SERVICE BULLETIN

SUBJECT TS-940S ANTENNA TUNER RELAYS	DATE 4-4-86
---	----------------

ADD

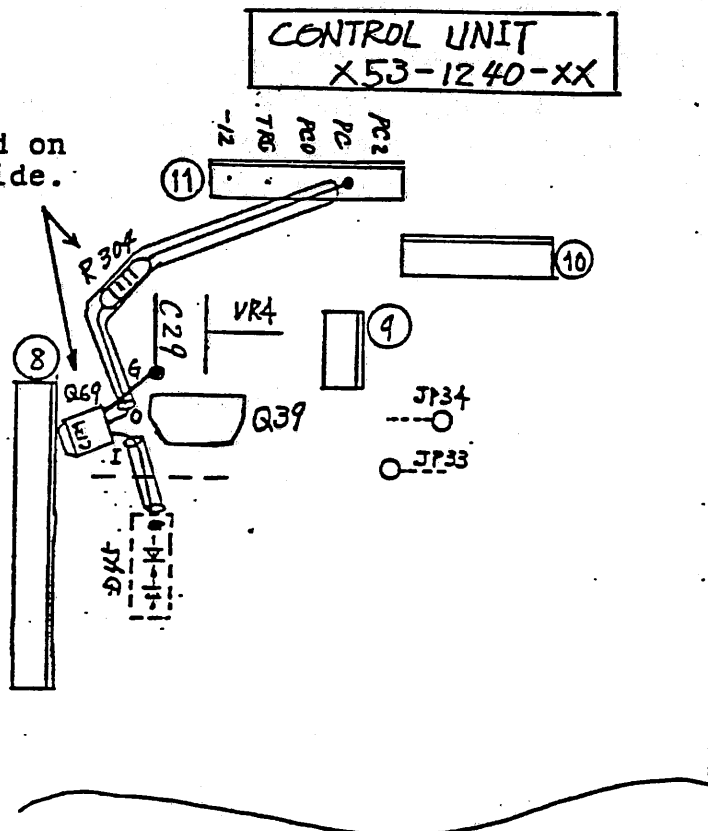
Occasionally during operation of the AT-940 a VSWR of greater than 1.5 to 1 might cause overloading of the relay contacts in the antenna tuner. This may be especially noticeable when switching BANDS, or if TUNING is performed too frequently. The following procedure should reduce or eliminate this tendency.

1. Add the circuit as shown below.
2. After the circuit has been installed adjust VR4 for a 10-15 watt output when the antenna tuner operates.

* Mounted on foil side.

Q69: Digital TransistorDTC124ES
R304: 5.6K ohm 1/6 W Resistor.....RD14BB2C562J
